Product / Process Change Notification (PCN)	
<input checked="" type="checkbox"/> Major change <input type="checkbox"/> Minor change	
PCN #: PCN_WS-TASV_20220501 Affected Series: 430783034816 ; 430773034825 430783051816 ; 430773051825 PCN Date: April 01, 2022 Effective Date: May 01, 2022	Change Category: <input type="checkbox"/> Equipment / Location <input type="checkbox"/> General Data <input type="checkbox"/> Material <input type="checkbox"/> Process <input checked="" type="checkbox"/> Product Design <input type="checkbox"/> Shipping / Packaging <input type="checkbox"/> Supplier <input type="checkbox"/> Software
Contact: Product Management Phone: +49 (0) 7942 - 945 5001 Fax: +49 (0) 7942 - 945 5179 E-Mail: pcn.eican@we-online.com	Data Sheet Change: <input type="checkbox"/> Yes <input checked="" type="checkbox"/> No Attachment: <input type="checkbox"/> Yes <input checked="" type="checkbox"/> No

Detail of Change:

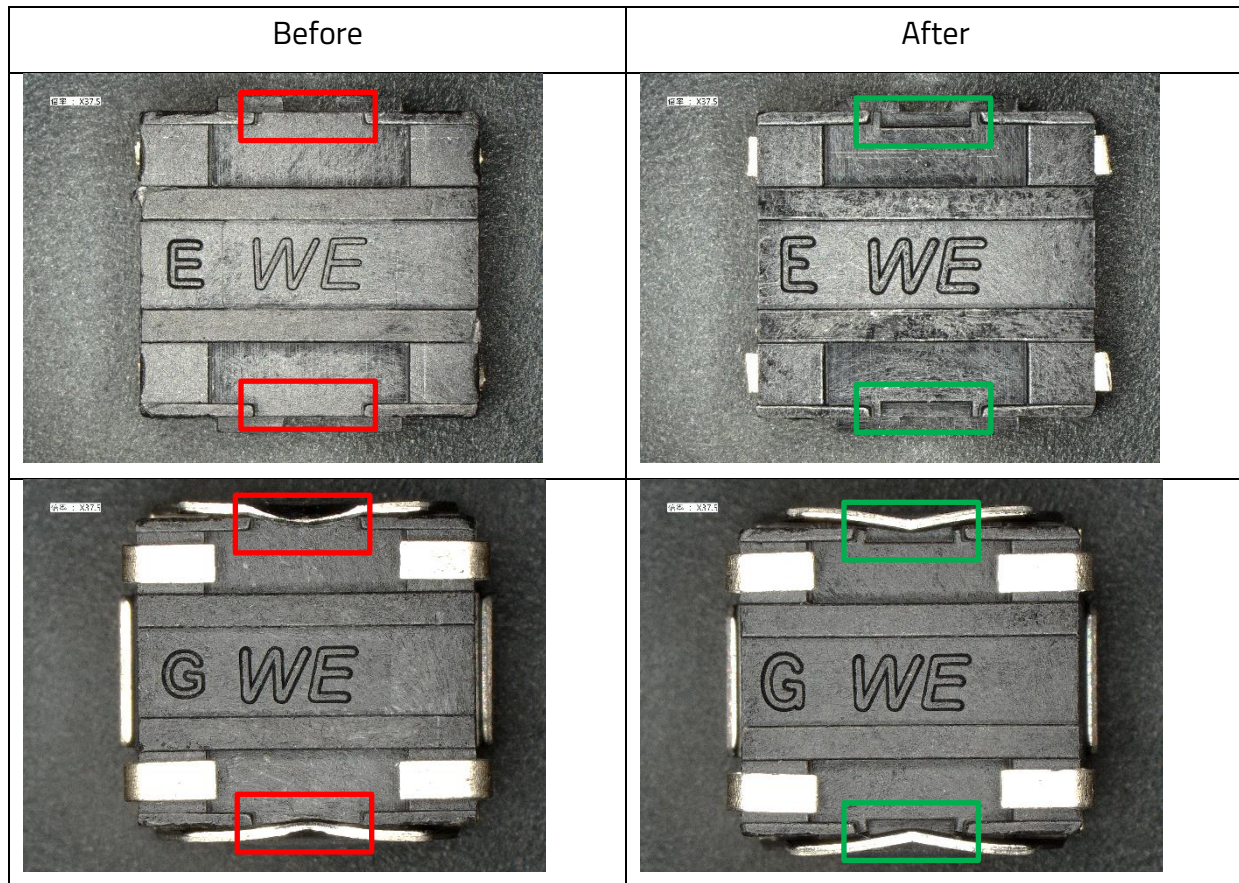
Description and purpose of change: In order to enhance the product reliability, Würth Elektronik will change the mold of frame for WS-TASV 4307x30xx8xx series. All products with date code 2022-04-25 or later, will be affected by this change. There will be no change in function, quality or reliability of the product.

Frame mold : the bottom shape, the middle of two sides
